# UNITED STATES PATENT AND TRADEMARK OFFICE

APPLICATION NO.	FILING DATE	FIRST NAMED INVENTOR	ATTORNEY DOCKET NO.	CONFIRMATION NO.
10/662,265	09/15/2003	Angelo V. Cuomo	33171-2020	9027
31013	7590	01/24/2006	EXAMINER	
KRAMER LEVIN NAFTALIS & FRANKEL LLP INTELLECTUAL PROPERTY DEPARTMENT 1177 AVENUE OF THE AMERICAS NEW YORK, NY 10036			FIDEI, DAVID	
			ART UNIT	PAPER NUMBER
			3728

<b>Office Action Summary</b>	<b>Application No.</b> 10/662,265	<b>Applicant(s)</b> CUOMO, ANGELO V.	
	<b>Examiner</b> David T. Fidei	<b>Art Unit</b> 3728

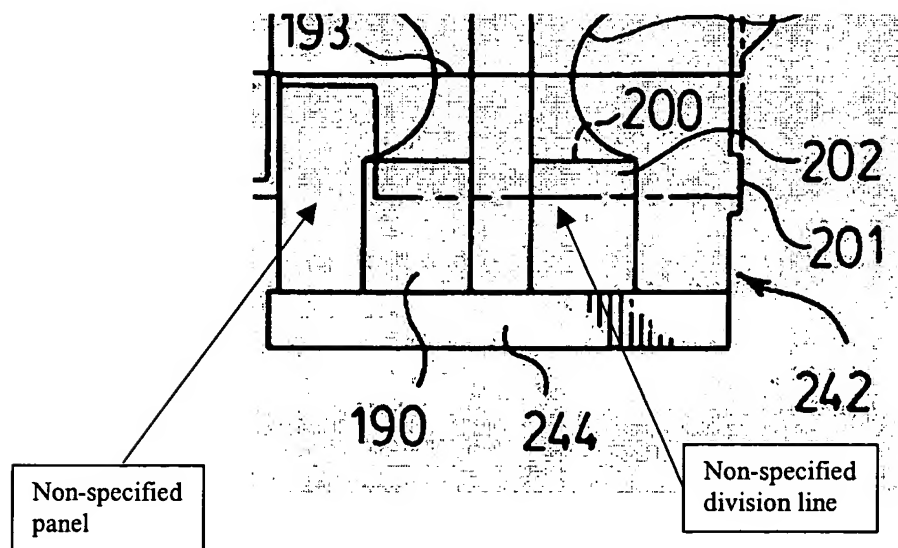
4. The drawings are objected to under 37 CFR 1.84(h)(5) because Figure 23 show(s) modified forms of construction in the same view. It appears to the examiner that the traverse

panel (242) is modified in some by an unspecified panel construction on the side of the pop out barriers. Also a dashed or broken line crosses a substantial portion of the transverse panel 242 this non-descript, see the figure reproduced below. Corrected drawing sheets in compliance with 37 CFR 1.121(d) are required in reply to the Office action to avoid abandonment of the application. Any amended replacement drawing sheet should include all of the figures appearing on the immediate prior version of the sheet, even if only one figure is being amended. The figure or figure number of an amended drawing should not be labeled as “amended.” If a drawing figure is to be canceled, the appropriate figure must be removed from the replacement sheet, and where necessary, the remaining figures must be renumbered and appropriate changes made to the brief description of the several views of the drawings for consistency. Additional replacement sheets may be necessary to show the renumbering of the remaining figures. Each drawing sheet submitted after the filing date of an application must be labeled in the top margin as either “Replacement Sheet” or “New Sheet” pursuant to 37 CFR 1.121(d). If the changes are not accepted by the examiner, the applicant will be notified and informed of any required corrective action in the next Office action. The objection to the drawings will not be held in abeyance.
